Report to: Mayor and Members of Council

From: Ian Clendening, Planner

Subject: Report #18-017 Planning
Assessment of Revised Claude Brown Road Boat Launch
Option

Figure 2 – Aerial View (Zoomed In)

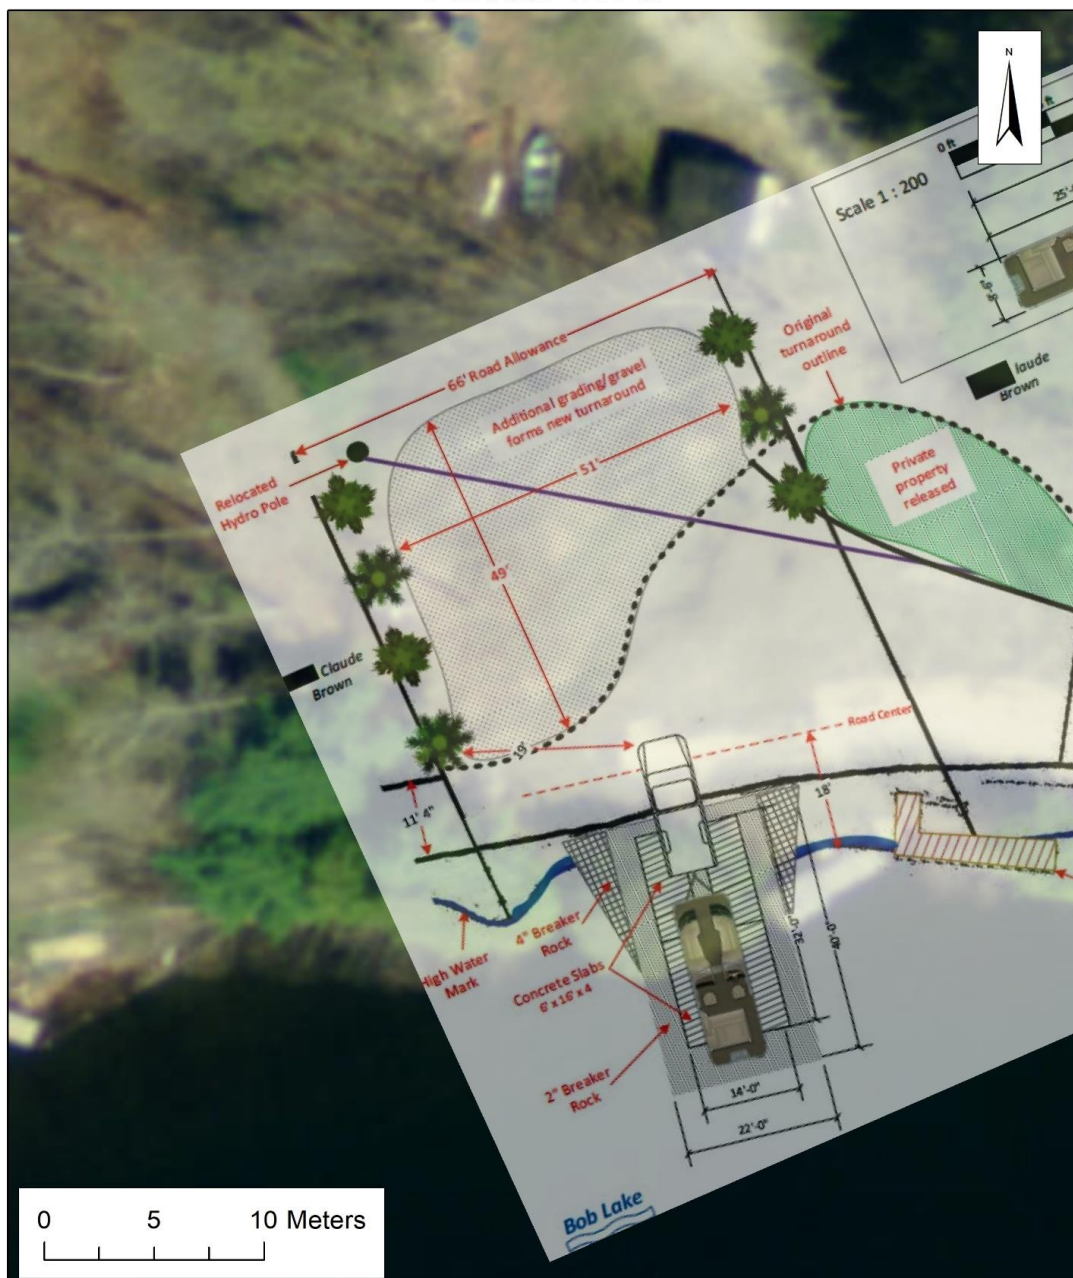
In large part the issues identified in the January 25, 2018 report remain unchanged. Under the revised proposal, the extent of encroachment of the parking/turnaround area has been mitigated; however, the issue remains. Additionally, in an effort to address the encroachment issue the revised configuration has exacerbated Staff's concerns related to storm water, and by extension water quality.

While detailed design drawings would provide more definitive measurements, the edge of the 4" breaker rock illustrated in Figure 1 & 2, would extend to a distance of 4m. (13'3") from the edge of the road allowance, and 4.4m. (14'6") from the edge of the dock steps.

Photograph 1 – Bob Lake looking North to Road Allowance

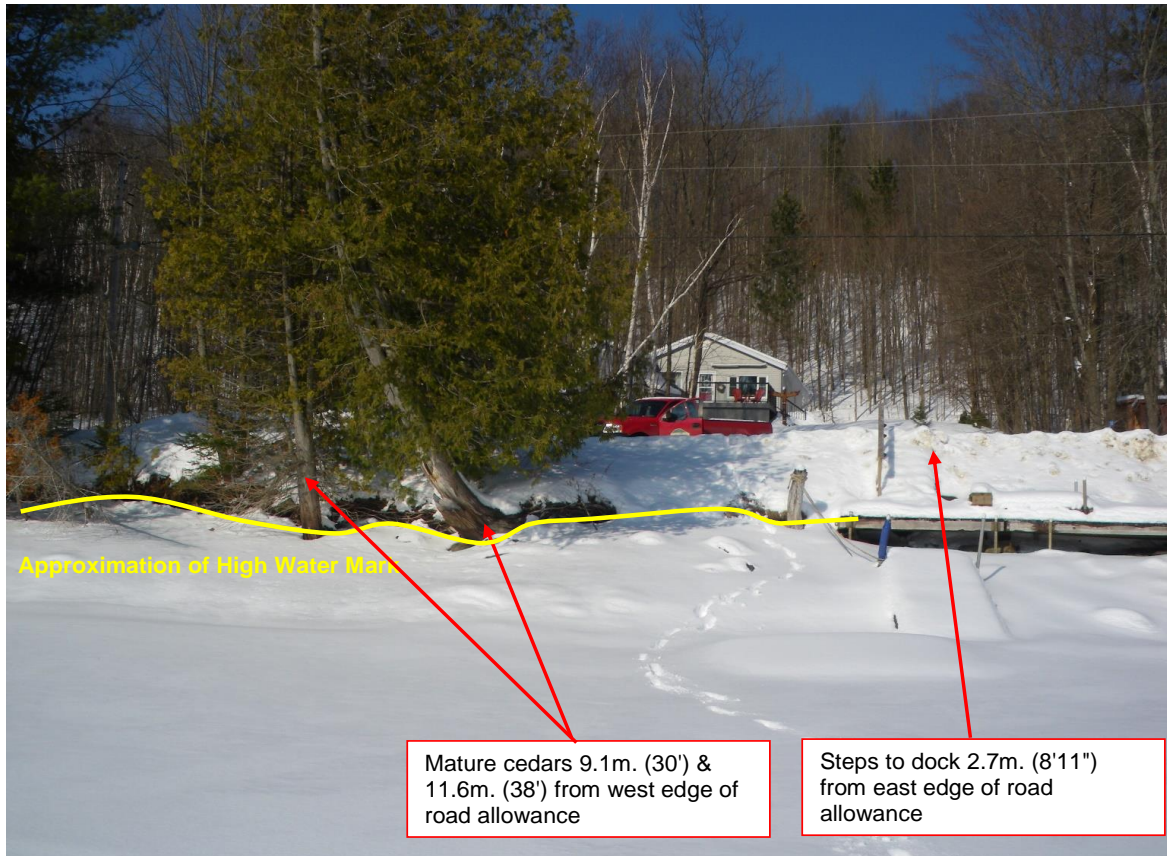
Photograph 1 illustrates the area of the shoreline upon which the boat launch is proposed. Based on the submission, the boat launch would be centred ~8.5m. (28') from the western edge of the road allowance.

The above also illustrates the steep topography in the area between the shoreline and the road. The elevation of the road is 0.6m (2') above the high water mark, resulting in slopes ranging from a high of 39% to a low of 17% at the location of the proposed boat launch.

Figure 4 – Zoning of Property (Excerpt from Schedule 10)

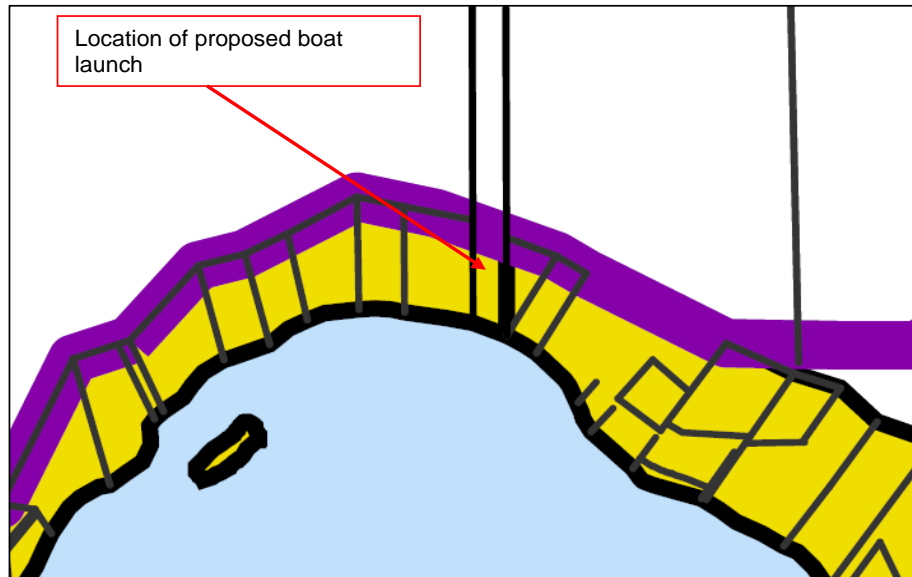
As identified in Figure 4 (following page) by the yellow colouring, the boat launch is located within the Shoreline Residential (SR) zone. Within the Shoreline Residential zone, a 4.5m. (14'9") setback is required from side lot lines as a means of ensuring privacy and reinforcing the character of a low intensity neighbourhood.

The parking/turnaround area is proposed to extend to a distance of 2.3m. (7'6") from each of the adjacent residential properties. The shed encroaching on the Township's road allowance would be situated ~ 4m. (13') from the northern limit of the parking/turnaround area.
